STAFF REPORT
COMMUNITY DEVELOPMENT DEPARTMENT

SUBJECT: H-2020-0064
 Pura Vida Ridge Ranch

LOCATION: 3727 E. Lake Hazel Rd., in the NW ¼ of Section 4, T.2N., R.1E
 Parcels: S1404212550 & S1404212750

B. Preliminary Plat (date: 8/24/2020) & Phasing Plan

C. Landscape Plan for Subdivision (date: 4/30/2020)

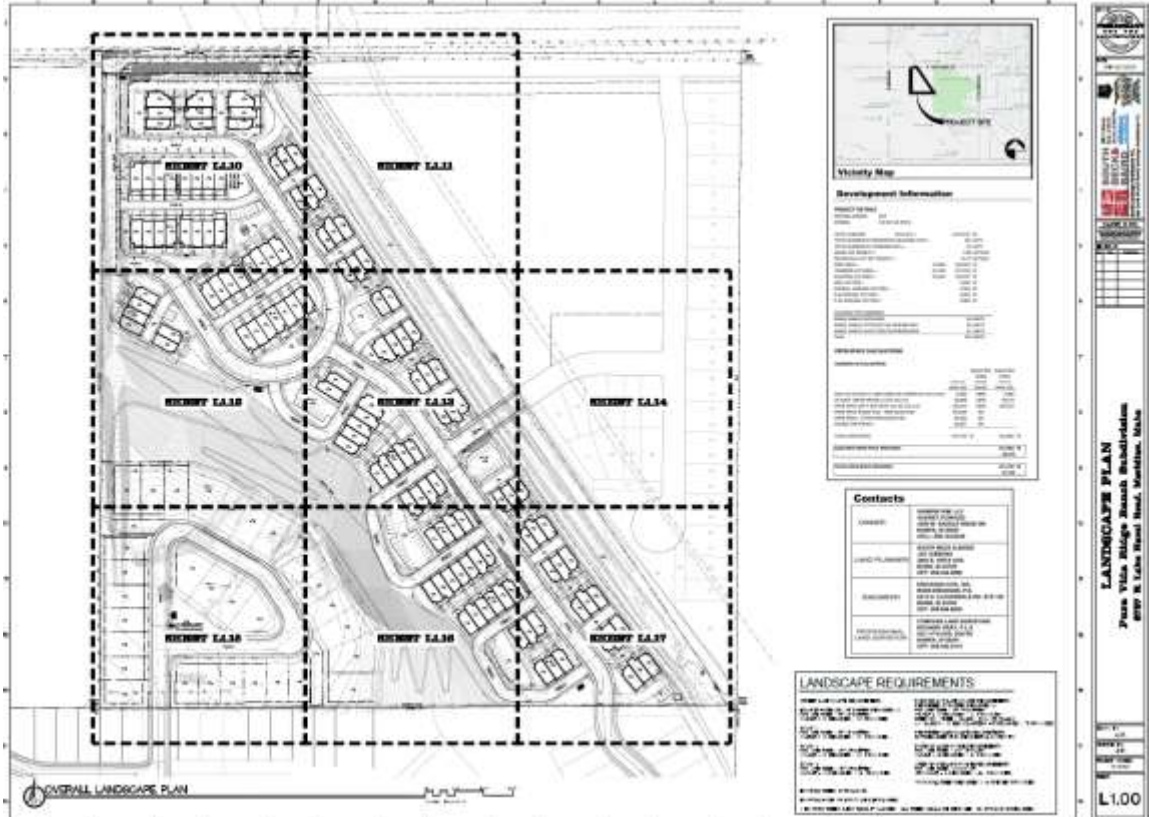
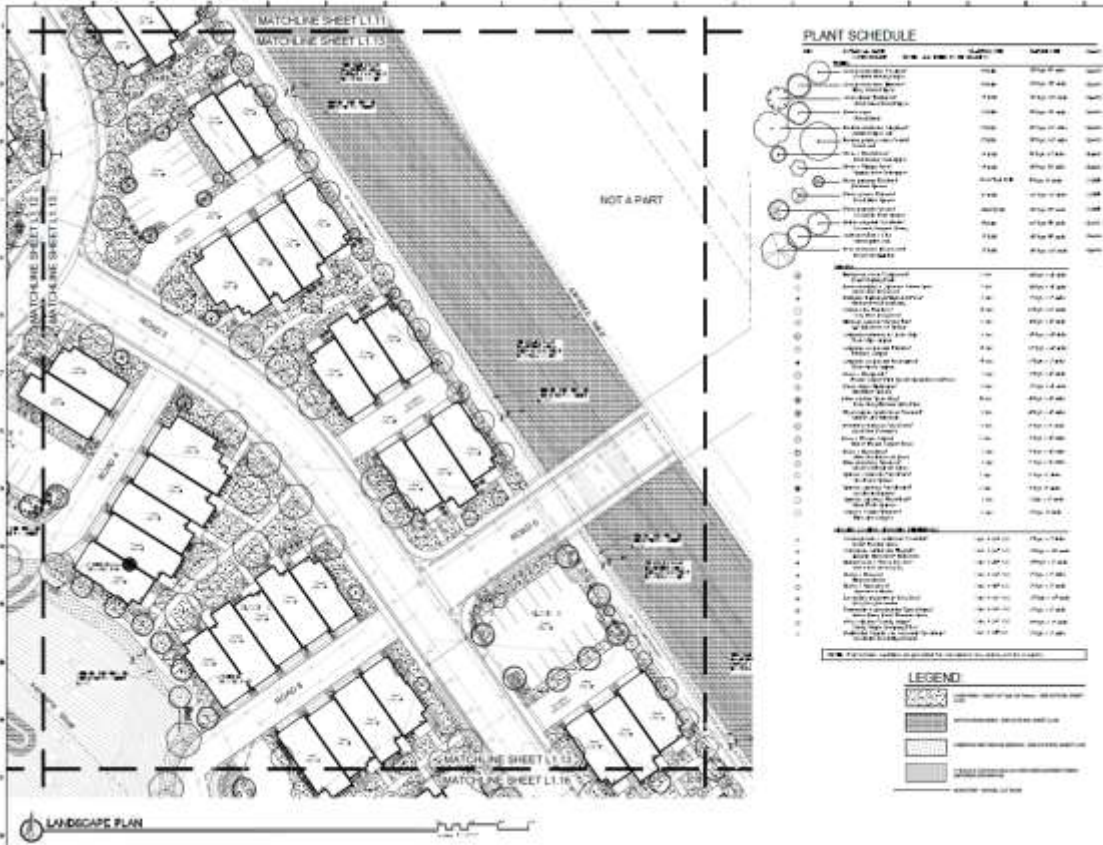
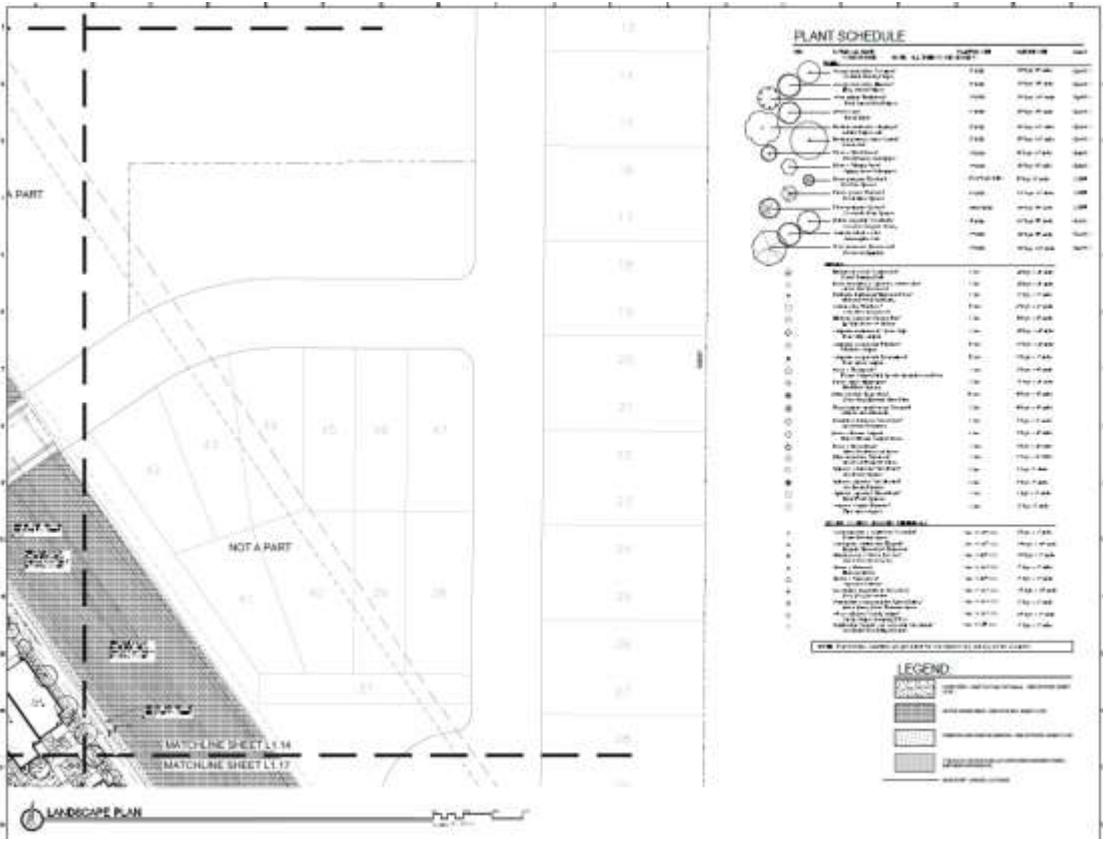
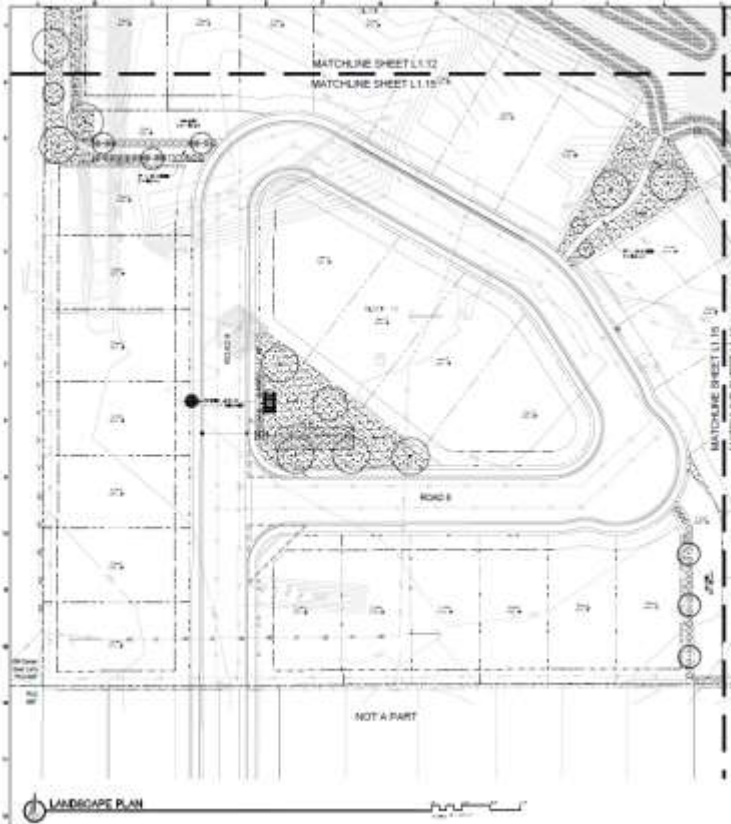
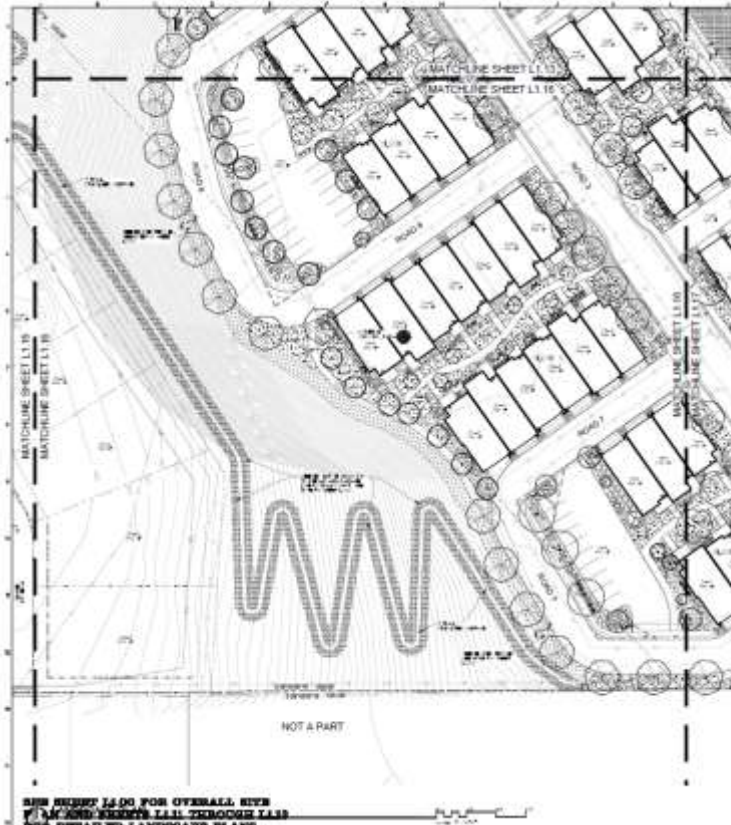
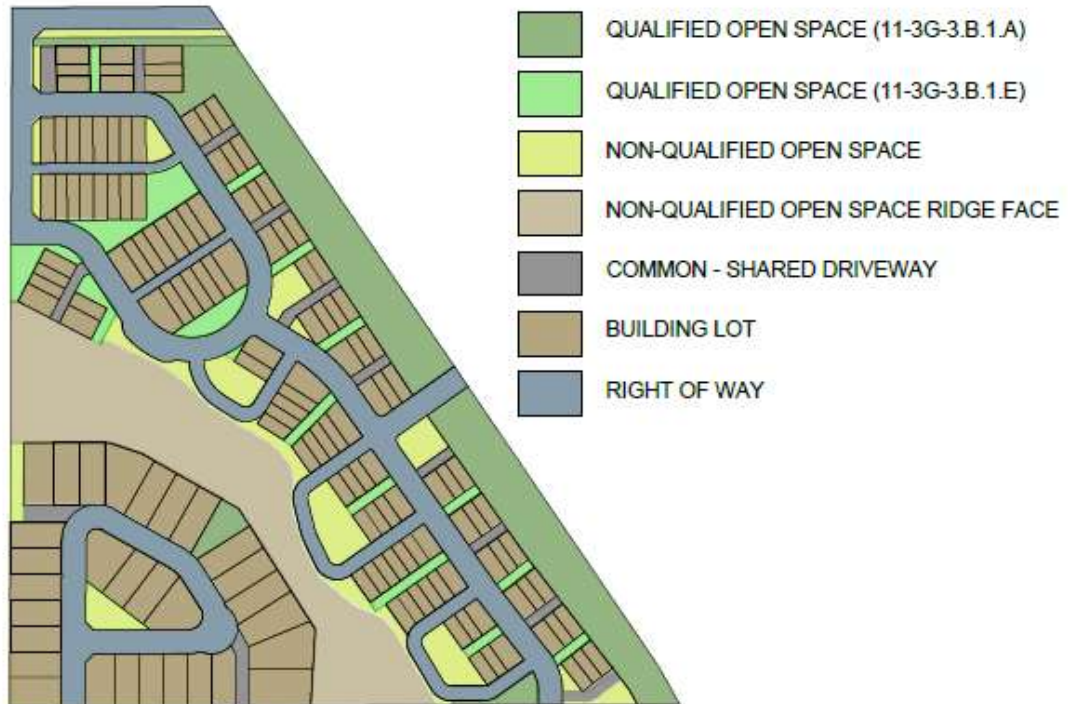
2. The preliminary plat included in Section VIII.B, dated August 24, 2020, is approved as submitted.
3. The landscape plan included in Section VIII.C, dated April 30, 2020, shall be revised as follows:

- a. Depict bushes within the buffer along E. Lake Hazel Rd. in accord with UDC 11-3B-7C.3.
 - b. Depict fencing abutting pathways and common open space lots to distinguish common from private areas per the standards listed in UDC 11-3A-7A.7; include a detail of the proposed fence.

- c. Depict a minimum 30-foot wide (may be increased to account for steep topography) defensible space extending out from any part of adjacent structures to the hillside in accord with Fire Dept. comments in Section IX.C. Hazardous and fire-prone vegetation shall be prohibited in this area and only fire resistant plants should be utilized for landscaping in this area.

F. Parking Exhibit

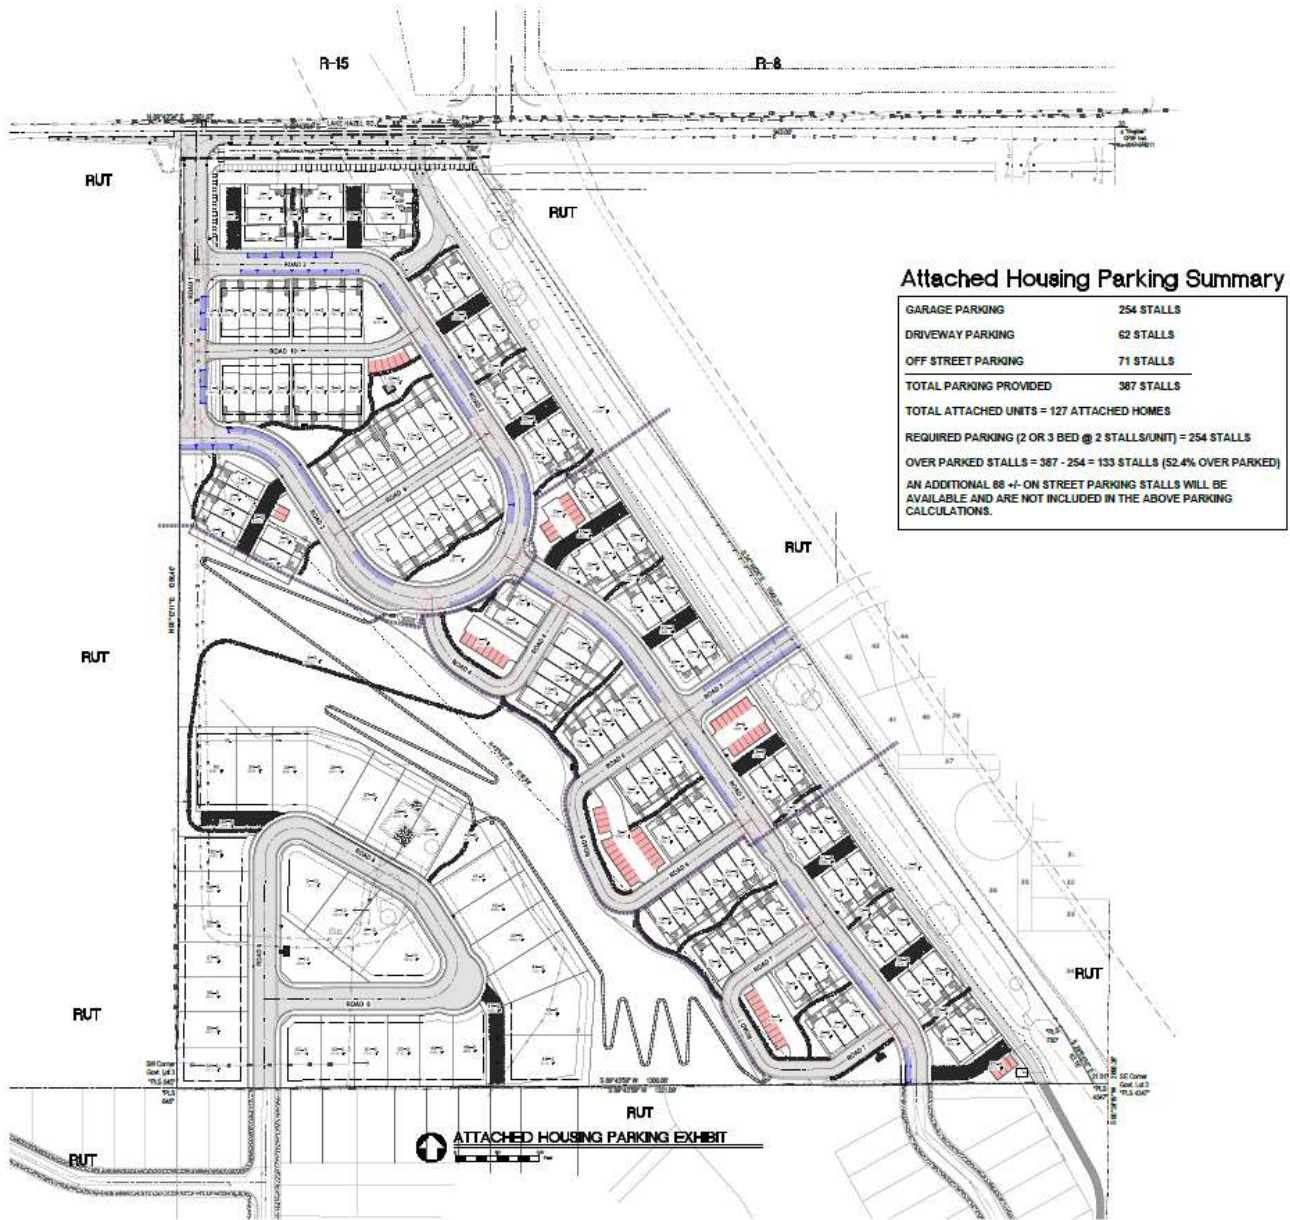
The Applicant is proposing 20’ long x 18’ wide parking pads, which are 2’ less in width than required. The parking pads should be revised to be 20’ x 20’ in accord with UDC Table 11-3C-6.

16. The parking pads for individual lots shall be revised to be 20' x 20' in accord with UDC Table 11-3C-6.
17. An exception was approved to UDC 11-3A-17D, which requires sidewalks to be constructed on both sides of all public streets, to only require sidewalks along the east sides of the 24' wide street sections (i.e. Roads 4, 6 and 7) adjacent to the parking areas as depicted on the Pedestrian Connectivity Plan in Section VIII.G *and* as required by ACHD (i.e. extend the sidewalks on the east sides of Roads 4 and 6 along the entire common lot/parking area).
